## Urgent Field Safety Notice

**Commercial name/Model:** *BeneFusion VP1, BeneFusion VP3 infusion pump*

**FSCA-identifier:** *JXXY-20170717*

**Type of action:** *Safety Notice and Device modification*

**Rate Abnormality Screening Method**

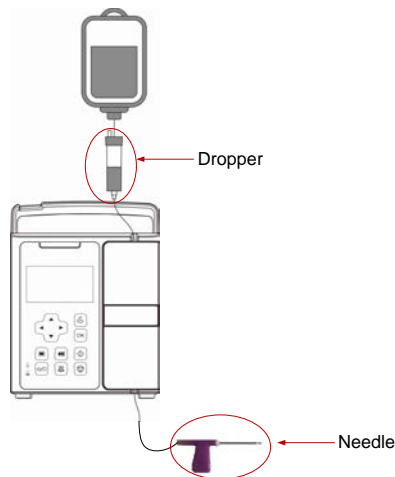
2. Please stop using the BeneFusion VP1, BeneFusion VP3 infusion pump in your facility. However, If you do not have alternative devices and want to continue to use the BeneFusion VP1, BeneFusion VP3 infusion pump, we advise you to do the following test before each infusion:

- 1). Fully prime the administration set with liquid;
  - 2). Load the administration set into the BeneFusion infusion pump and close the door;
  - 3). Open the Robert clamp and flow rate regulator of the set;

- 4). Observe the dropper or needle for 30 seconds:
    - a) If any drop drips or increases gradually, then the flow rate is abnormal, pump should be removed from clinical use and quarantined.

- b) If NO drop drips or increases gradually was observed, then the infusion pump could be used normally for this infusion.
